September 22, 2022

**RE: Jabaay Townhomes
1423 6th St. NW
Grading and Drainage Plan
Engineer's Stamp Date: 8/15/2022
Hydrology File: J14D201**

DRAINAGE PLAN

C-2

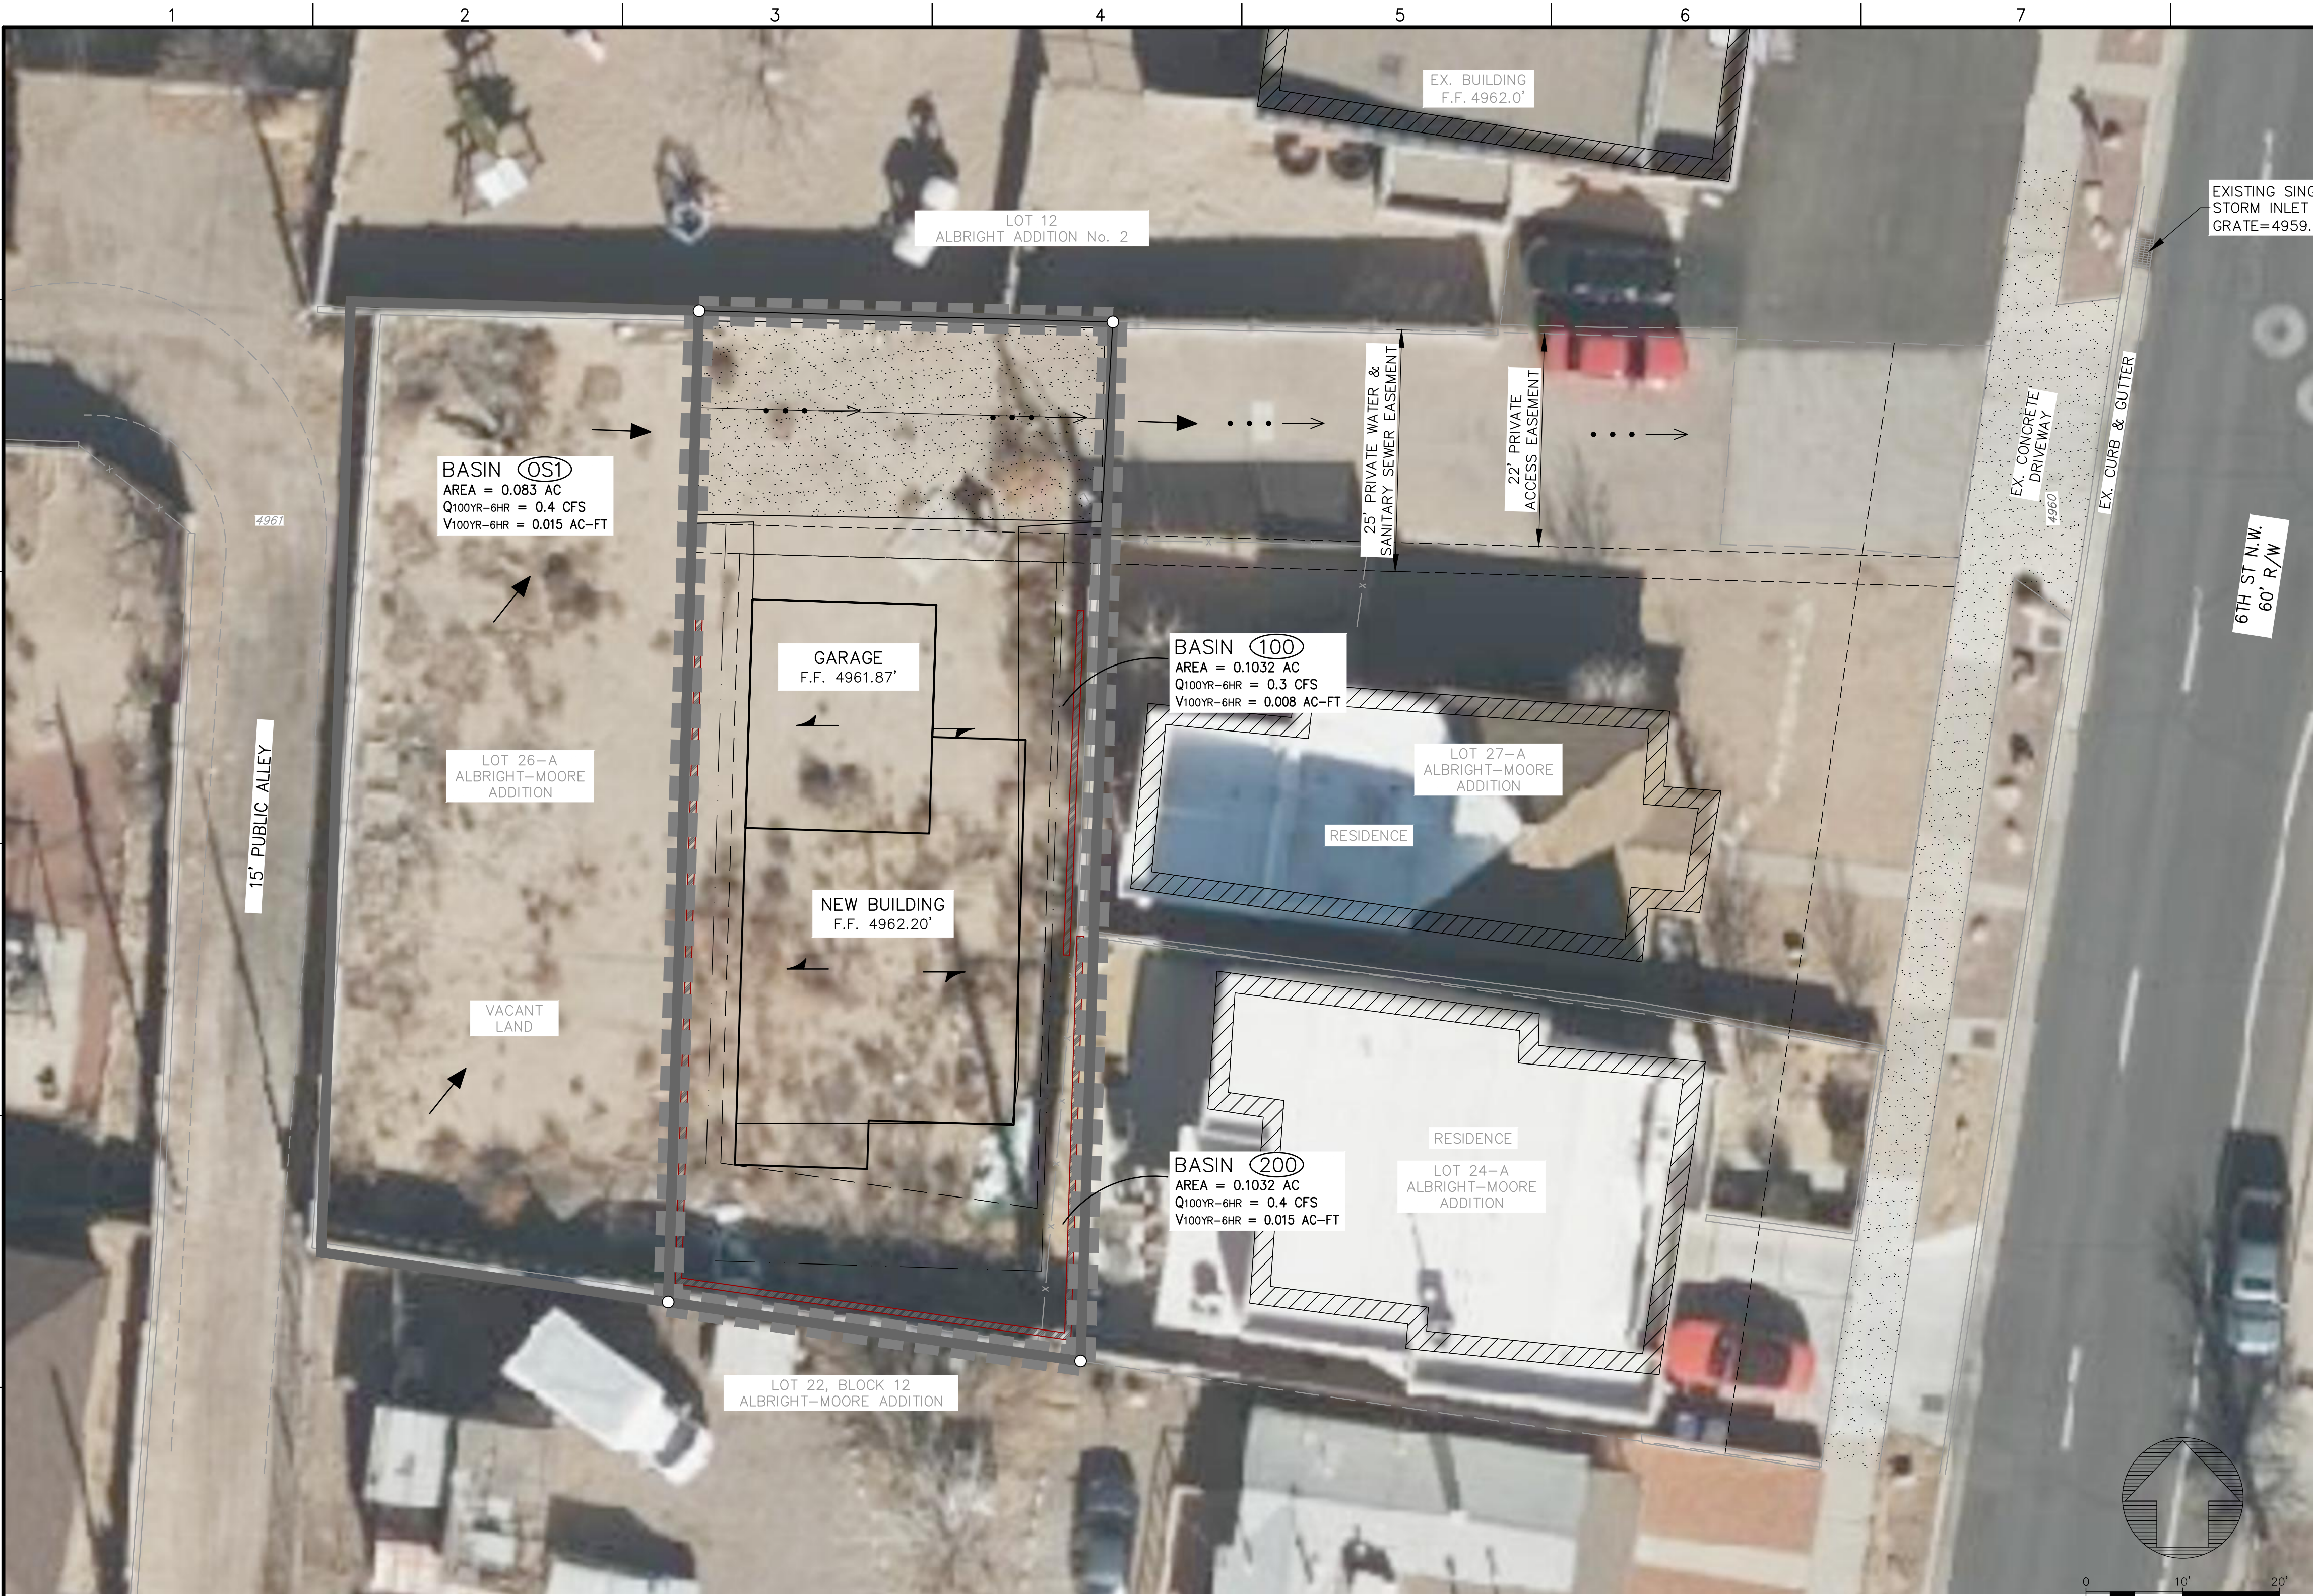
Based upon the information provided in your submittal received 08/16/2022, the Grading & Drainage Plan is approved for Grading Permit and Building Permit since the pad is essentially already rough graded.

Please attach a copy of this approved plan in the construction sets for Building Permit processing along with a copy of this letter. Prior to approval in support of Permanent Release of Occupancy by Hydrology, Engineer Certification per the DPM checklist will be required.
